PLANNING DEPARTMENT STAFF REPORT AND FINDINGS:

PUBLIC HEARING: THE RESERVE, PHASES 3–6–Preliminary Subdivision Approval (File: SUB 22-16)

The request is for preliminary approval for Phases 3 through 6 of The Reserve At Junction City Subdivision. The proposal is for 271 lots on 81.47 acres of land, distributed as follows: Phase 3=90 lots; Phase 4=92 lots; Phase 5=62 lots and Phase 6=27 lots. The proposal also calls for five (5) stormwater detention ponds, labeled Tracts A–E; two (2) stormwater detention swales; and thirteen (13) public streets. Six (6) of the public streets will be extensions of existing streets and seven (7) will be new streets. The new streets will be named prior to final plat approval.

ADA impact at new proposed 10th Ave connection

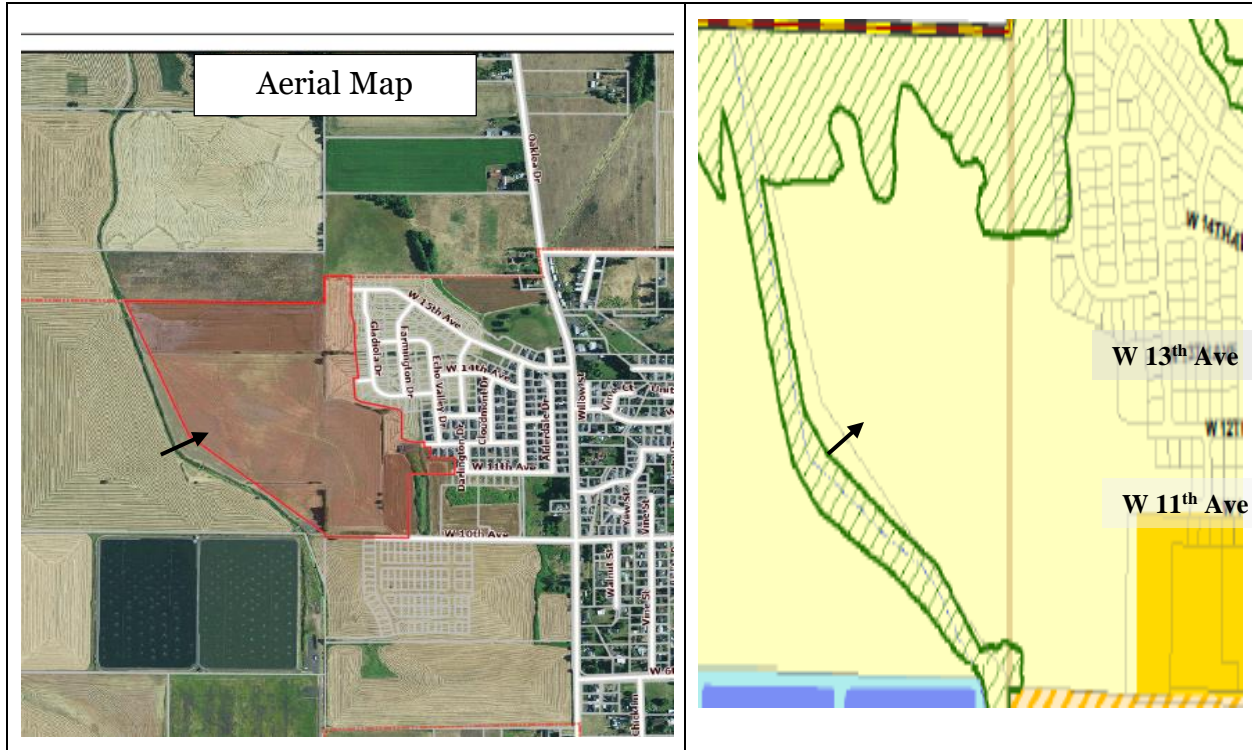
- Lane County scope of study includes a review of completed frontage and roadway improvements with applicable Lane Code requirements. Please provide an analysis of 10th Ave intersection improvement status and identify deficiencies relative to current ADAAG, PROWAG and Lane County Code specific requirements.
- An analysis of required transitions between improved and unimproved sections and identification of a responsible party is required.
